SERVICE BULLETIN

Classification: EC21-023	Reference: NTB22-001	Date: January 12, 2022
-----------------------------	-------------------------	---------------------------

DTC P0300 AND/OR P0301(2/3/4/5/6) IS STORED DURING A COLD START

APPLIED VEHICLES: 2022 Frontier (D41)

Figure 1

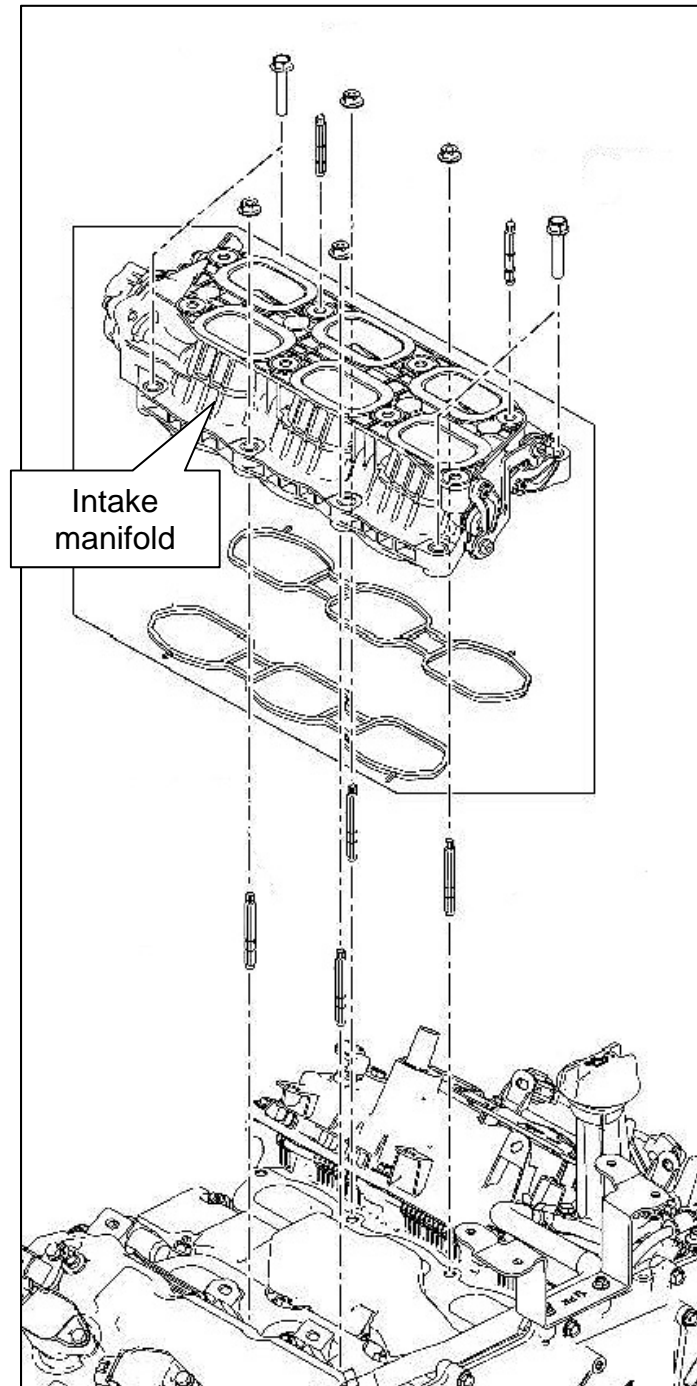
4. Replace the intake manifold (Figure 1) with one listed in the **PARTS INFORMATION** on page 4.
 - Refer to the ESM: **ENGINE > ENGINE MECHANICAL > VQ38DD > REMOVAL AND INSTALLATION > INTAKE MANIFOLD**

DESCRIPTION	PART NUMBER	QUANTITY
Intake Manifold	14001-9BT0B	1
Gaskets	14035-9BT0A	2 (1)
Gaskets	14032-9BT0A	2 (1)
